ADDENDUM NO. CC-1

to the  
Bidding Documents

BLOOMER ELEMENTARY SCHOOL  
REMODEL  
210 S. 7<sup>th</sup> Street  
Council Bluffs, Iowa 51503  
BCDM Project No. 3103-01

## addendum

sketch **E3-2a**

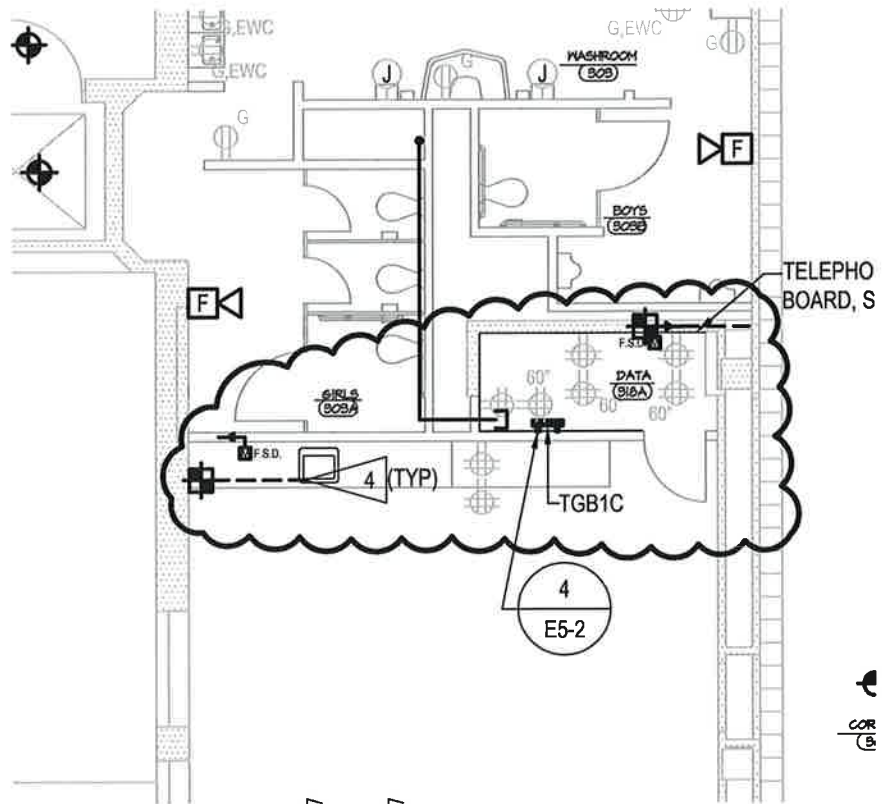
11. Sheet E3-2 Second Floor Plan - Special Systems
  - a. See Sketch E3-2a

- 1 RECONNECT EXISTING MAGNETIC DOOR HOLDERS TO FIRE ALARM SYSTEM.
- 2 THIS ROOM, PROVIDE ONE (1) DATA/COMMUNICATION ROUGH-IN, SEE 1/E5-1, PROVIDE ONE (1) AV ROUGH-IN SIMILAR TO 1/E5-1, AND ONE TELEPHONE OUTLET ROUGH-IN. ALL NEW ROUGH-INS IN THIS ROOM SHALL BE METAL WIREMOLD STYLE SURFACE RACEWAY COORDINATE ROUGH-IN LOCATIONS WITH OWNER.
- 3 PROVIDE PROJECTOR MOUNT, CHIEF #KITP S006W. COORDINATE PROJECTOR MOUNT LOCATION WITH OWNER PRIOR TO INSTALLATION. RELOCATE CEILING MOUNT RECEPTACLES NEXT TO NEW PROJECTOR MOUNT LOCATION. EXTEND RECEPTACLE CIRCUITS TO ACCOMMODATE NEW LOCATION. FINAL PROJECTOR INSTALLATION BY OWNER.
- 4 DUCT SMOKE DETECTOR SHALL CLOSE ASSOCIATED DAMPER UPON DETECTION OF SMOKE.
